PRELIMINARY
NOT FOR
CONSTRUCTION

SOLANDER 38
STEERING COMPONENTS
LONG'L SECTIONS AT P&S DUMMY SHAFTS
3"=1'-0" / 11" X 17"
HJN 8/20/25
SHEET 3 OF

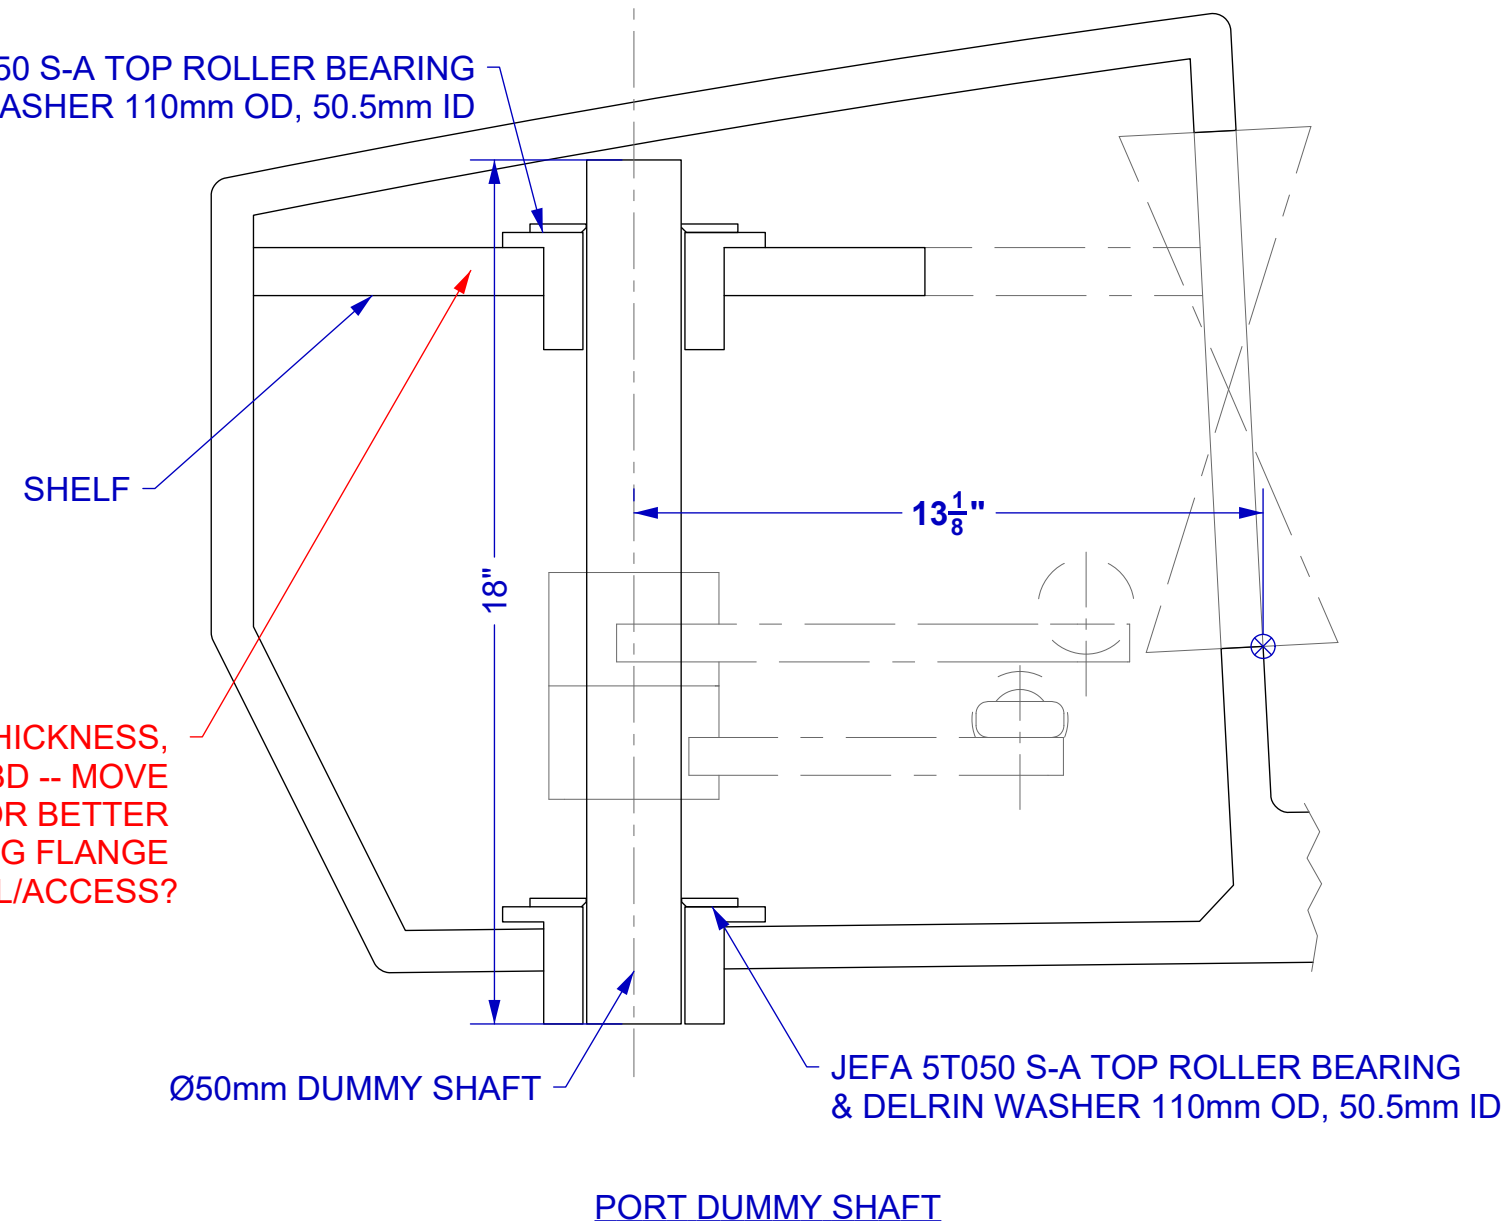
SHELF HEIGHT, THICKNESS, MATERIAL TBD -- MOVE DOWN FOR BETTER BEARING FLANGE INSTALL/ACCESS?
